Title HEPI 8-Channel Valve Driver			
Size: C	DCC Number: D020373	Ligo Project California Institute of Technology Massachusetts Institute of Technology	
Drawn by: Ben Abbott	Date: 5/7/2009	Revision: v2	
File: Z:\boards\HEPI 8CH Valve Driver Board D020373 Revv2\Schematics\8ChannelValveDriver.sch 1 of 2

Title HEPI 8-Channel Valve Driver			
Size: A	DCC Number: D020373	Ligo Project California Institute of Technology Massachusetts Institute of Technology	
Drawn by: Ben Abbott	Date: 5/7/2009	Revision: v2	
File: Z:\boards\HEPI 8CH Valve Driver Board D020373 Revv2\Schematics\ValveChannel6560M Sheet 2 of 2

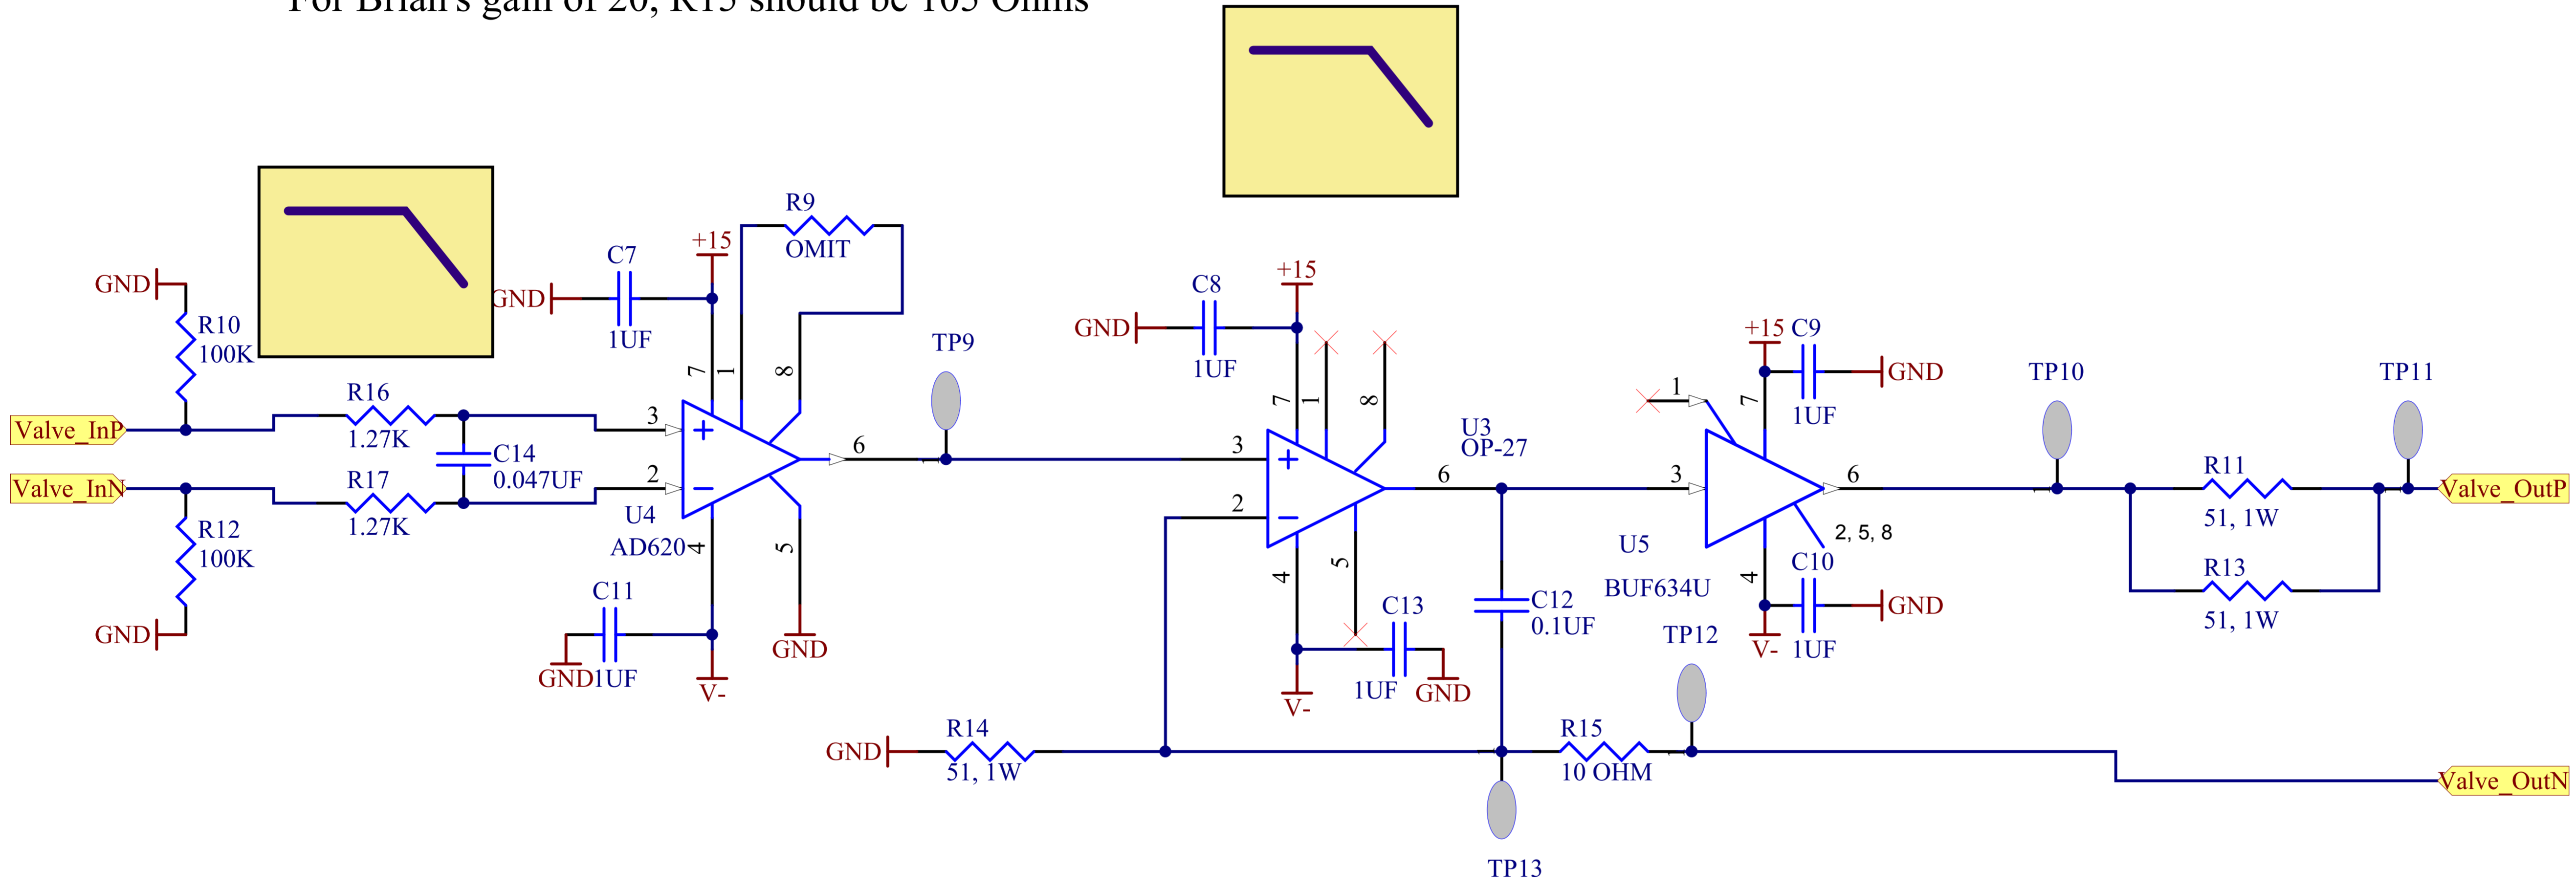
For Brian's gain of 20, R15 should be 105 Ohms
